Re: Termination of NRC License # R-73

REQUEST FOR ADDITIONAL INFORMATION
UNIVERSITY OF WASHINGTON RESEARCH REACTOR
FINAL STATUS SURVEY REPORT
DOCKET NO. 50-139

UW More Hall Annex Decommissioning Project Document Comments Form

Document		Final Status Survey Report	Document No.: UW-MCP-OP-13 Rev. 1
Commenter(s)		NRC Docket # 50-139 RAI (February 7, 2007)	Document Date: December 6, 2006
			Project Number 10492

PROJECT	UNIVERSITY OF WASHINGTON NUCLEAR REACTOR DECOMMISSIONING	 Enercon Services	Scale: NTS
DRAWING	FUEL STORAGE PIT LAYOUT SURVEY UNIT 1-3		Drawn by: MN
			DRAWING 9

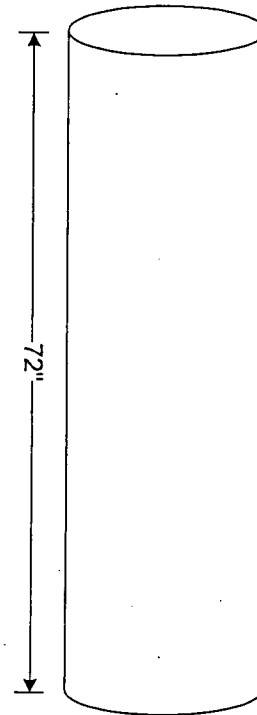
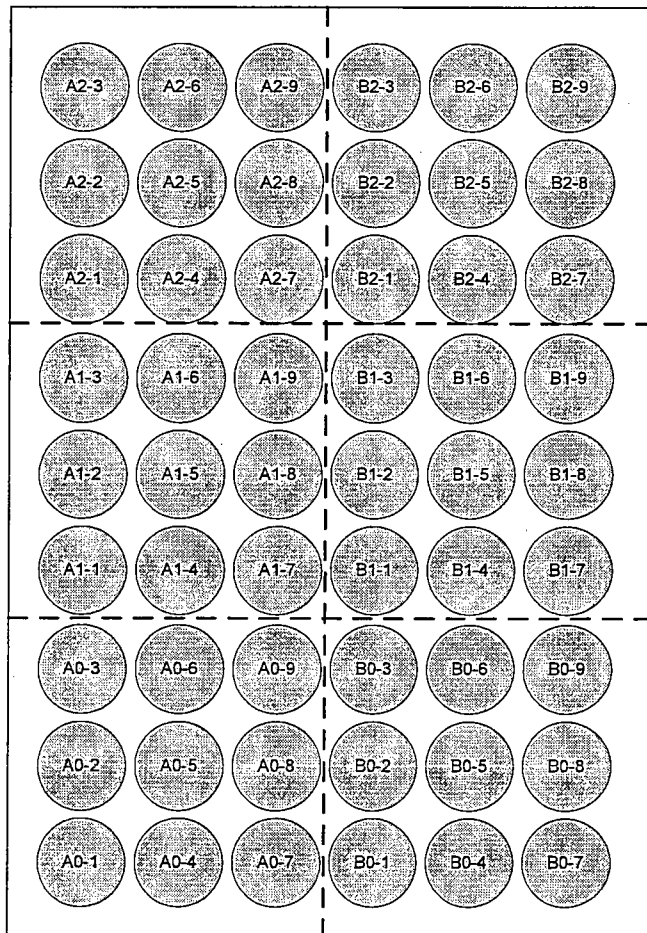
3. Section 7.1.3.3 describes the use of a 50 cm² air proportional detector for assessing total alpha activity inside the fuel storage tubes (10 cm diameter). Table 7-2 describes three elevated alpha activity results and the associated weighted average. Please provide the source-to-detector distance and the method of determining the net results in dpm/100 cm² (e.g., was the measurement result doubled since the detector is 50 cm² in area?). Discuss if the source-to-detector distance results in an underestimation or overestimation in the efficiency and results.

PROJECT	UNIVERSITY OF WASHINGTON NUCLEAR REACTOR DECOMMISSIONING	 Enercon Services	Scale: NTS
DRAWING	BIOSHIELD WALLS SURVEY UNIT 1-3		Drawn by: DM
			DRAWING 15

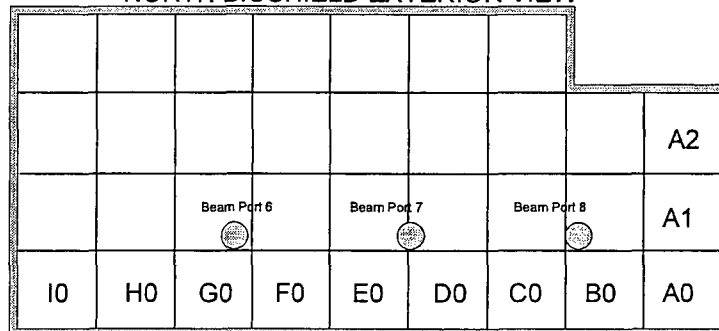
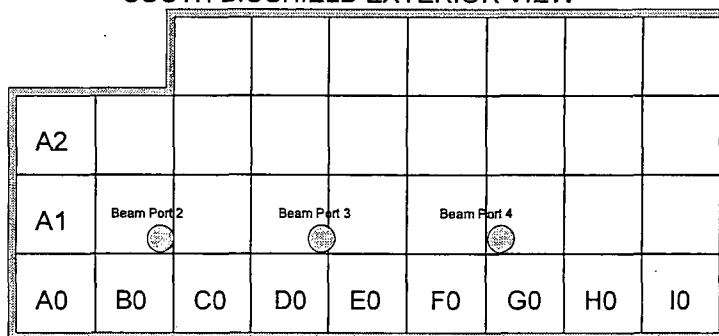
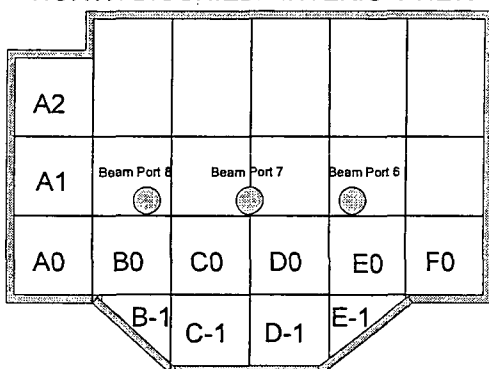
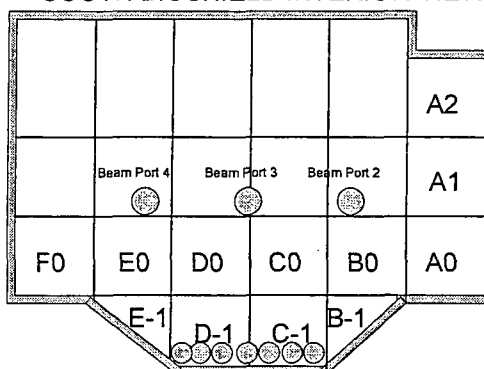
5. Because of your revision to release criteria that occurred after NRC's site visit to account for tritium, please collect and submit additional measurements around two locations of interest on the bioshield floor (grid location B,1) and bioshield interior south wall (grid location E,-1), to verify that the square-meter average is less than the modified average beta contamination limit of 1,700 dpm/100 cm². The individual measurement results for these locations were 3,700 and 1,800 dpm/100 cm², respectively.

5	N/A	<p>Because your revision to the release criteria that occurred after the NRC's site visit to account for tritium, please collect and submit additional measurements around two locations of interest on the bioshield floor (grid location B,1) and bioshield interior south wall (grid location E, -1), to verify that the square-meter average is less than the modified average beta contamination limit of 1,700 dpm/100cm². The individual measurement results for these locations were 3,700 and 1,800 dpm/100cm², respectively.</p>	<p>Material was collected from these two locations immediately following the completion of the final NRC site inspection. This material was sampled and analyzed to develop the Hard To Detect nuclide fraction and revised release criteria. These locations were immediately resurveyed and the results were included as part of the evaluated FSS data in UW MCP-OP-13 Rev 1. The final beta value for floor location B,1 is 413 dpm/100cm² and the final value for wall location E,-1 is 617 dpm/100cm².</p>
